Service Bulletin

Release of NX 3.0.21.00 with XRDl 20.0 and ASC 6.0

Title:	DX-D 100 - SB112 - Release of NX 21.00
Livelihood ID:	66086365
Version#:	6
Version Date:	2018-09-18 10:48 AM CET
Status:	Approved on 2018-09-25 12:58 PM CET
Owner:	Stephan Schneider (erzhf)
Created By:	Stephan Schneider (erzhf)
Created Date:	2018-09-07 04:02 PM CET
PDF Creation Date:	2018-09-25 12:58 PM CET

Figure 1

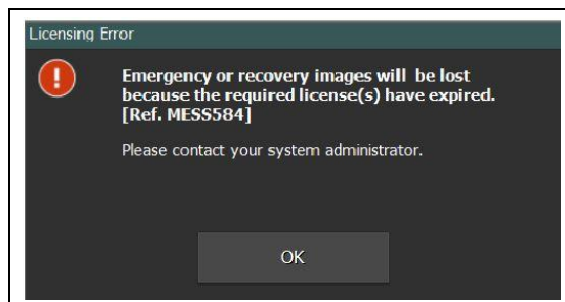
1.1.3 Licensing error after each NX restart in CR only configuration [PRB2000084]

Symptom At DR systems with a CR only configuration, a Licensing Error is displayed with each restart of NX. Contents of the error message (displayed in user language): **Emergency or recovery images will be lost because the required license(s) have been expired [Ref. MESS584]**.

When clicking OK, NX operates normal. This error has no influence on emergency or recovery images.

Cause Software issue in NX 20.00 (SU1).

Workaround Click OK to close the window. Message can be ignored.

Solution The issue is solved in NX 21.00.
